ASME Meeting with U.S. Nuclear Regulatory Commission

ASME Code Sections III & XI Risk-Informed Code Cases

*ASME Code Case N-660 – “Risk-Informed Safety Classification for Use in Risk-Informed Repair/Replacement Activities,” Section XI, Division 1**

LETTER BALLOT COMMENT FORM

Figure I-1
Risk-Informed Safety Classification Process

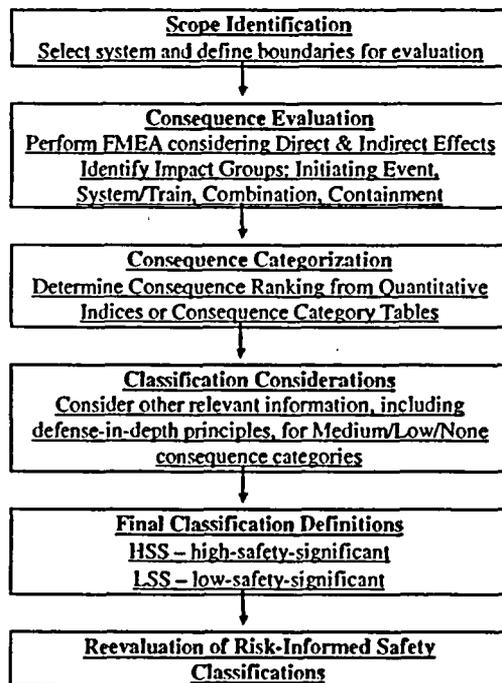
PAGE & PARAGRAPH REFERENCE	D/C	COMMENTS AND/OR RECOMMENDATIONS	DISPOSITION OF COMMENTS
Figure I-1		The RISC process steps are incomplete as shown in Figure I-1 and should be revised to include a final step identifying the requirement for Reevaluation of Risk-Informed Safety Classifications and the titles and numbering of the major Sections (e.g., I-2.0, I-3.0, I-4.0, etc.) should reflect what is in this Table and not mixed up as they are now and thus I-3.0 should be re-titled as CONSEQUENCE EVALUATION and I-3.1 should be "Analysis and Assessments," etc.	Change made to Figure I-1 and Section titles (I-3.0 and I-3.1).
I-2.0		I believe that this requirement would be much clearer if The following words were deleted from the beginning of the second sentence: "Items optionally classified to Class 1 and," and then just start the sentence as: "Class 1 items connected to the ...," and the reference to 10 CFR 50.55a (c)(2)(i) and (c)(2)(ii) will sufficiently cover the exceptions.	Change made to requirement in - 1200(b).
